ACOG is required to submit the information and advice below (working with the relevant ACP sponsor – in this case NERL).

ACP Reference: ACP-2017-70	Date: 29 Jan 2021
Sponsor: NATS En Route Limited (NERL)	Stage 2 Gateway Date: 26 Feb 2021

FIGURE 1: Lateral extent of the LD1 ACP & potentially affected areas of interdependent ACPs

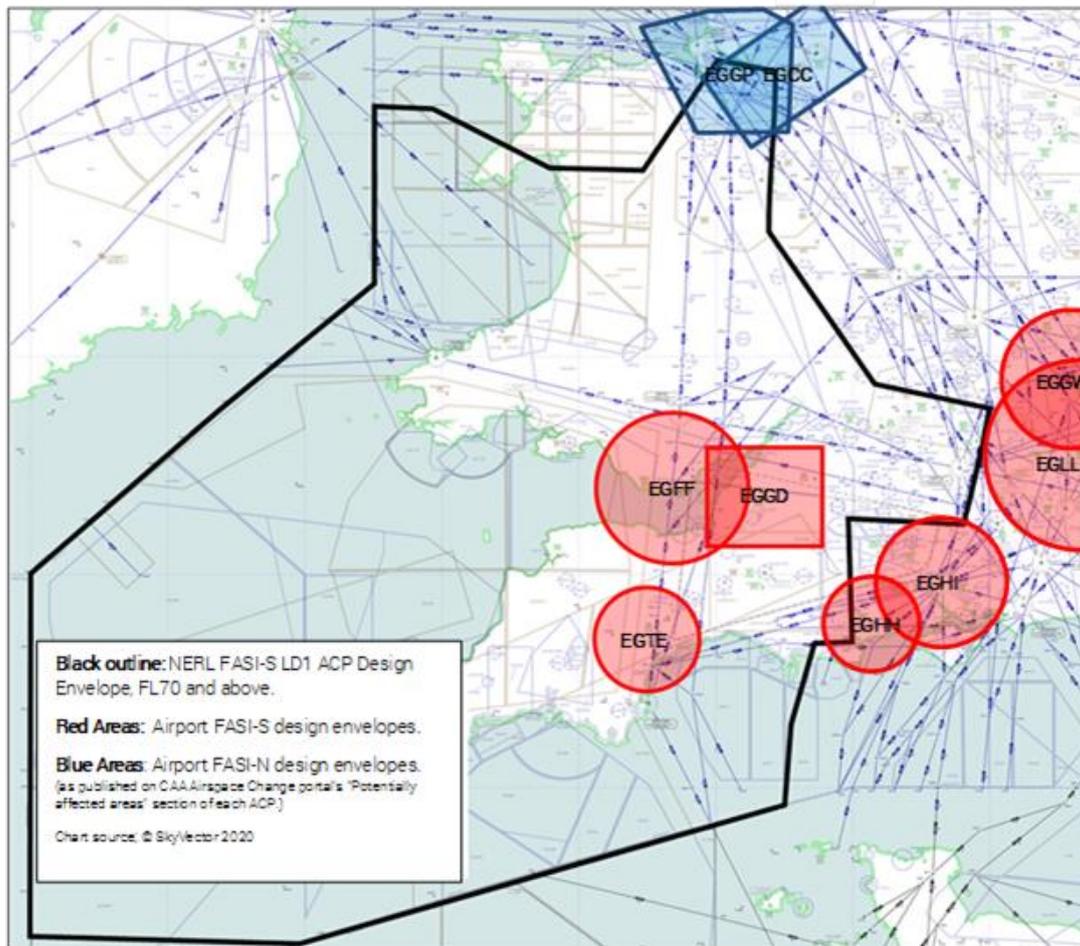
3. This form suggests providing a graphical representation of the design envelopes associated with each of the LD1 airspace design options to illustrate how all possible routes considered in the proposal may interact with the current operations and future airspace designs of the interdependent airports. Due to the size and scale of the LD1 area, NERL has not used design envelopes to illustrate the potential options or areas of interdependency. Instead, the lateral extent of the LD1 ACP is set out graphically in Figure 1.

4. ACOG and NERL have assessed the potential interactions with other ACPs by overlaying the lateral extent of the LD1 proposal with the 'potentially affected areas' of future FASI South airport-led ACPs (taken from the CAA Airspace Change Portal). The main flows of traffic covered by the LD1 options are above 7,000ft allowing subsequent low-level airspace designs to be developed in other ACPs that link new departure and arrival routes into the airways structure above.
